ADDENDUM No. 03

Date: February 28, 2019

Coaldale Government Building

Project No.: 9030

Drawing Title
**RAISED WEST PARAPET AT HIP
 ROOF SECTION DETAIL**

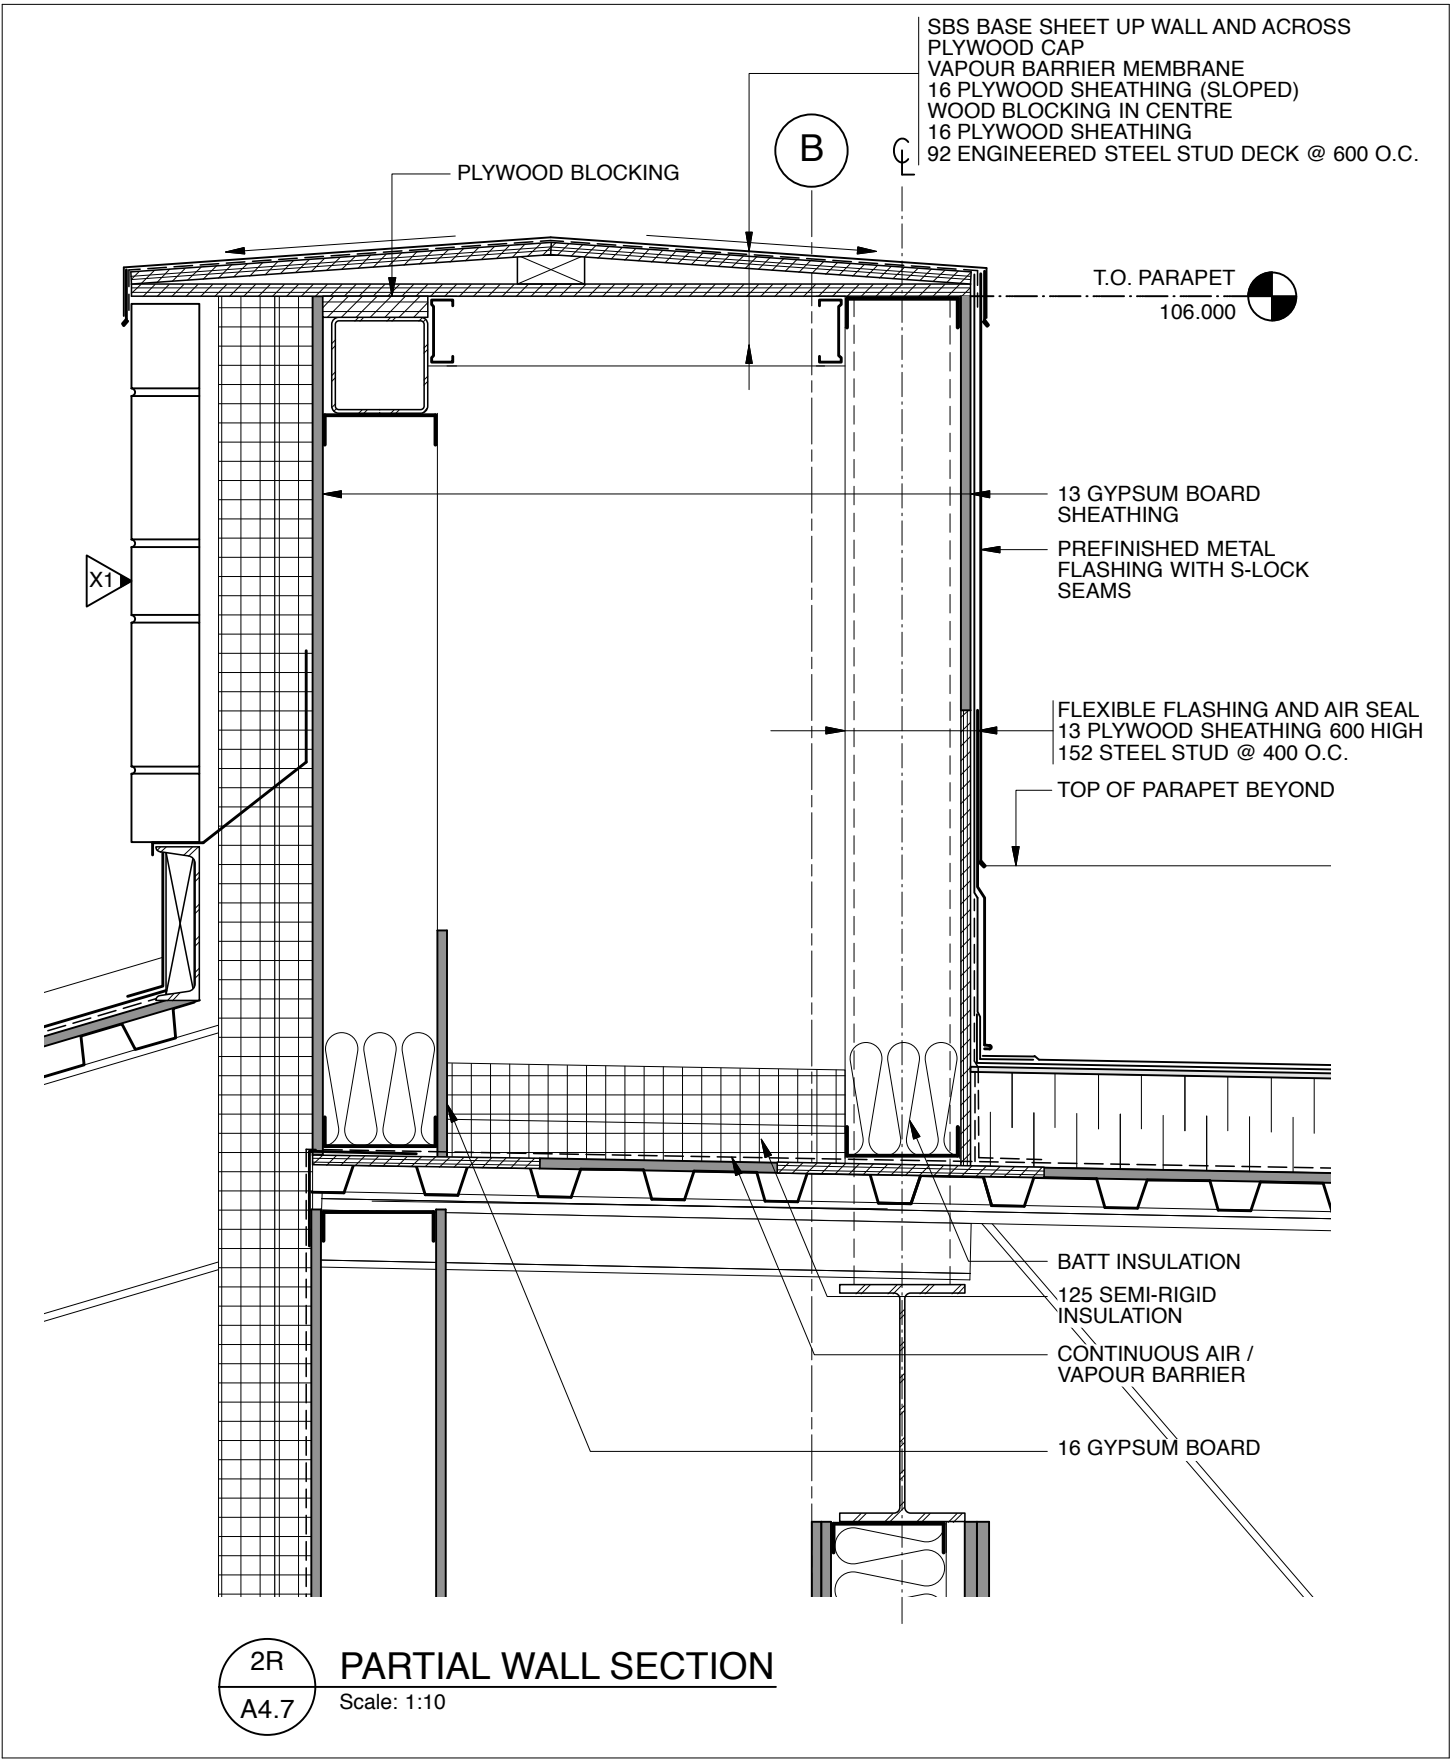
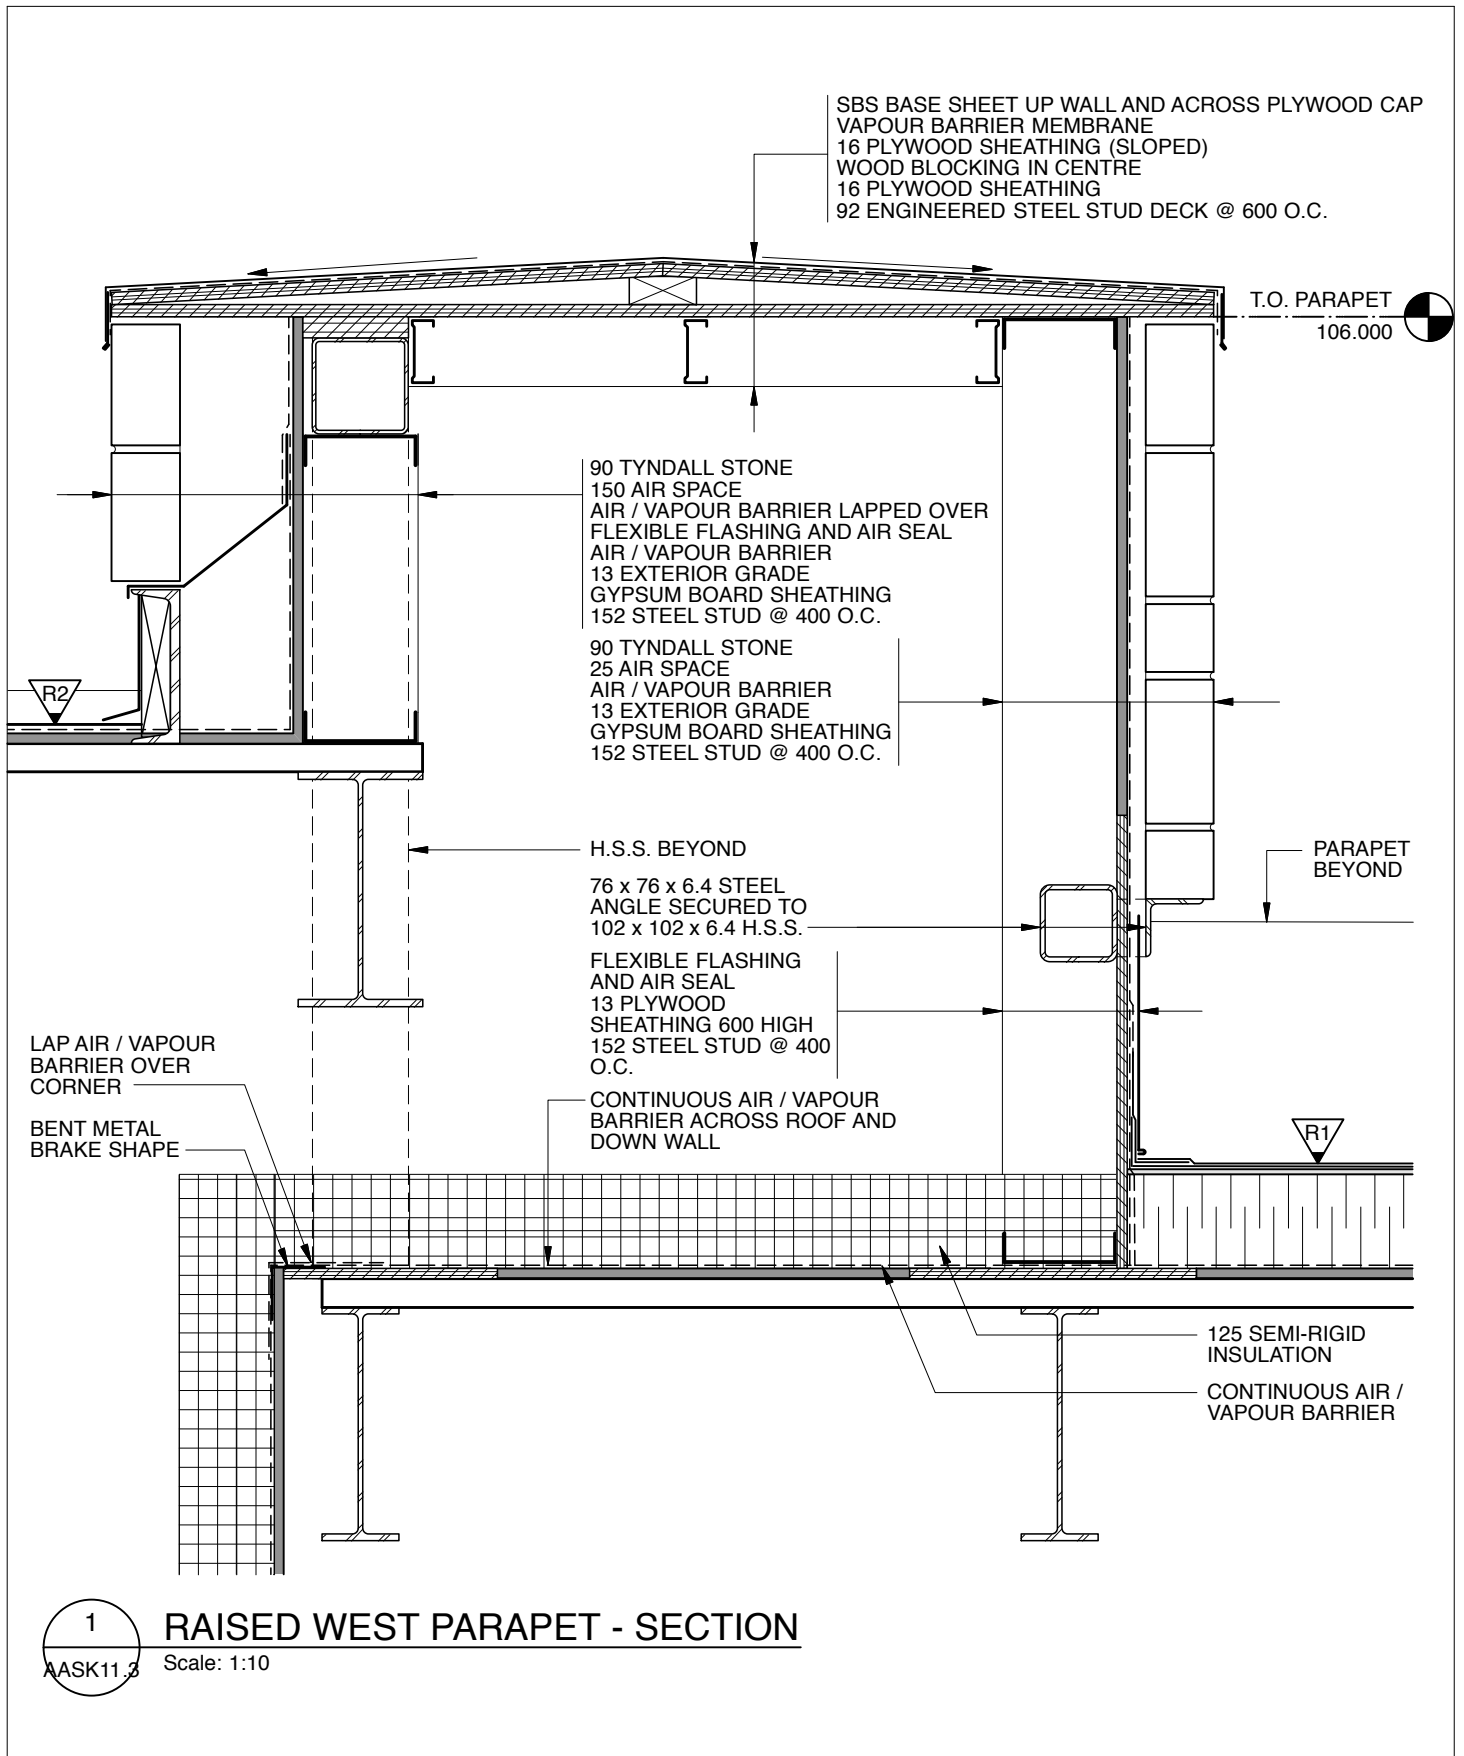
- .9 A4.7 – Wall Sections**
 - .1 6/A4.6 – Section Detail
 - .1 Add: “provide continuous 150 x 200 sheet metal over roof/wall corner.
 - .2 Add: “vapour retarder under roof insulation to be as specifications in spec section 07 52 00.”
 - .2 1/A4.7, 2/A4.8 and 3/A4.8
 - .1 Detail 6/A4.6 applies
 - .3 2/A4.8 – Wall Sections
 - .1 Refer to AASK 11.3 for revisions to Roof R1 wall junction at gridline B.

- .10 A4.8 – Roof Plan Large Scale North Hip Details**
 - .1 1/A4.8 North Roof Plan.
 - .1 Refer to revised Roof Plan AASK11.1
 - .2 Add AASK 11.2 and 11.3 referring to additional sections through the canopy roof.

REVISED PILE SPACING AT APRON ALONG GL 12

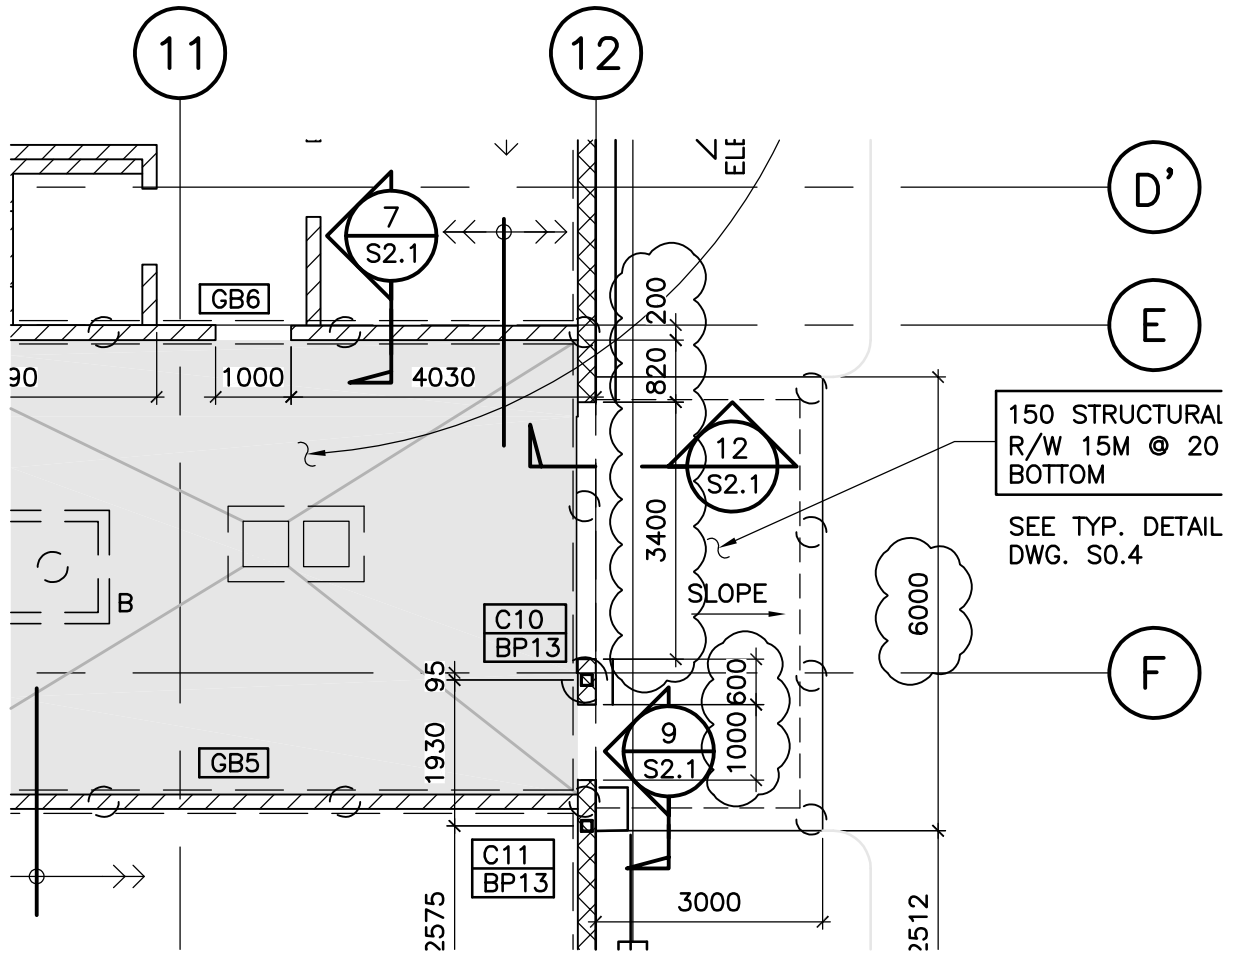
.1.1 Revise pile dimensions under apron along gridline 12 (+2850) between gridlines E (-838) and F (+1900) as clouded on SSK-031.

REVISED DIMENSIONS OF O/H DOOR LOCATION
ALONG GL 12

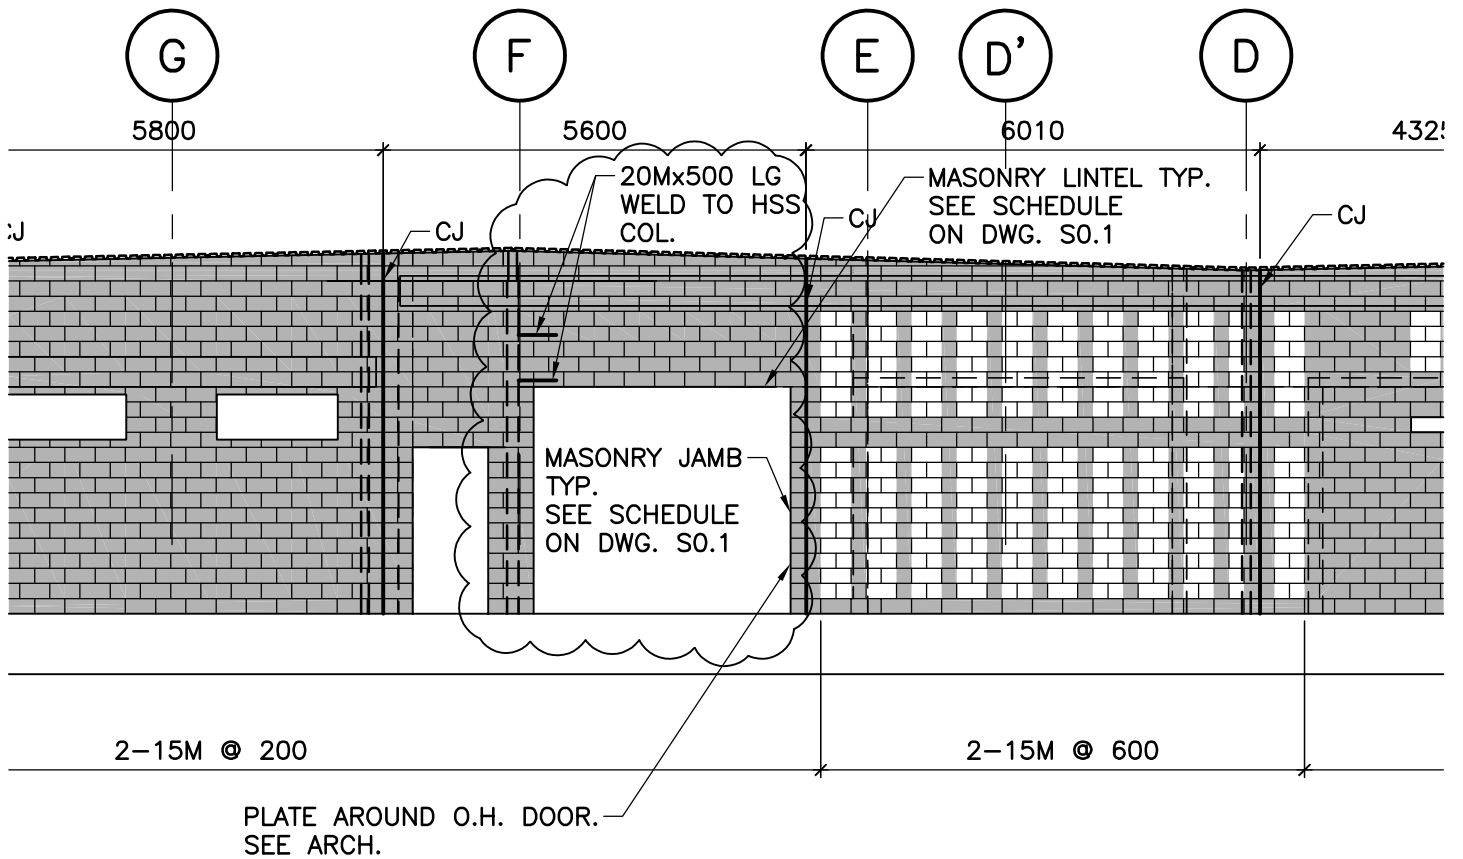
.2.1 Revise dimensions of O/H door location along gridline 12 between gridlines E and G and extend apron 200 to the north as clouded on SSK-032.

DRG. TITLE: **REVISION TO ELEVATION B ON S4.1**

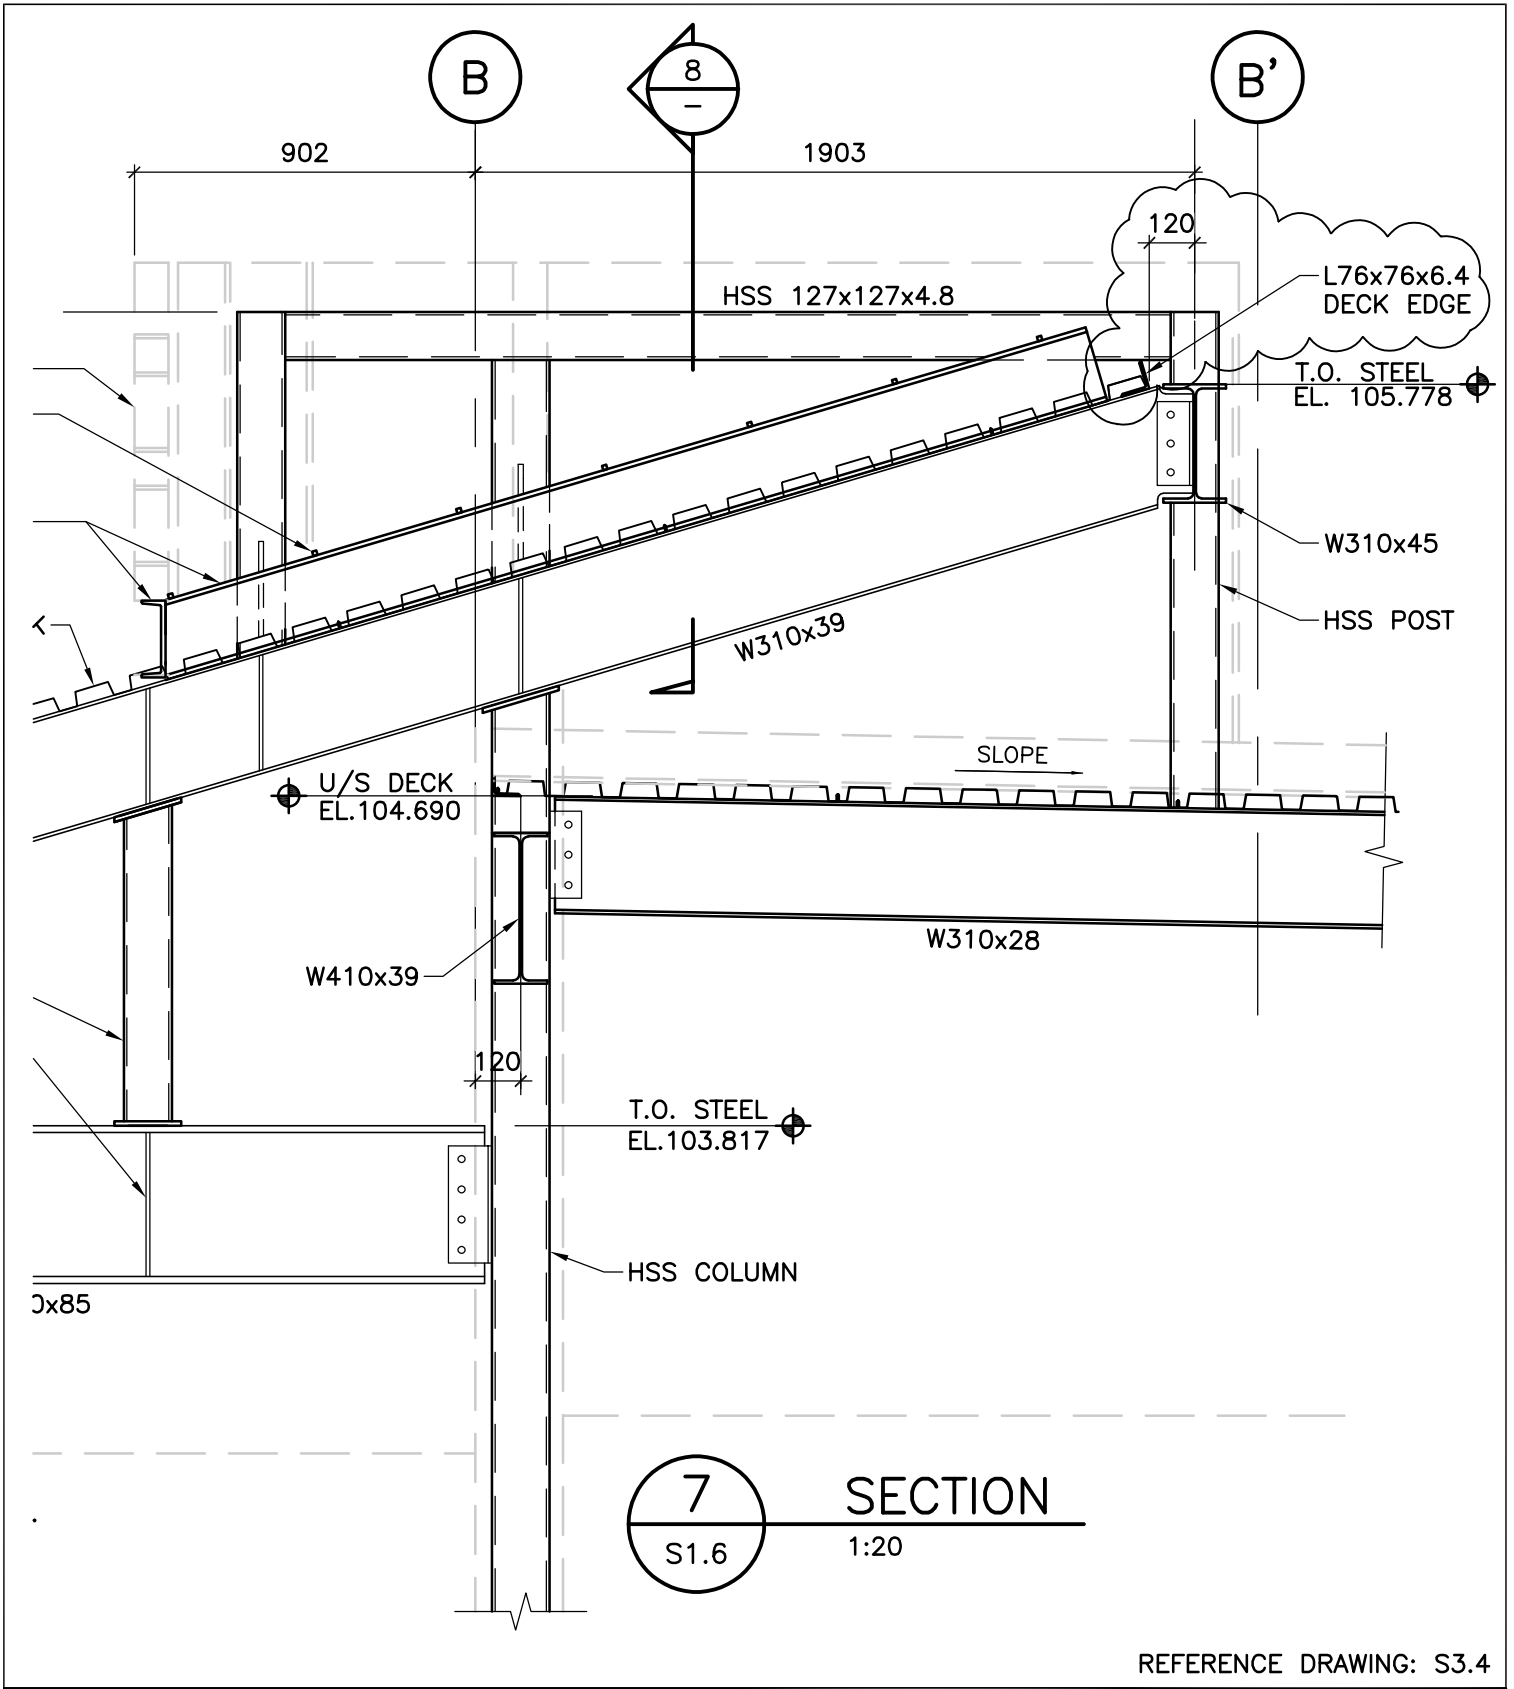
.3.1 On B Elevation on GL 12 (East), move O/H door between gridline F and E 200 to north and add note '20Mx500 LG Weld to HSS' as clouded on SSK-033.
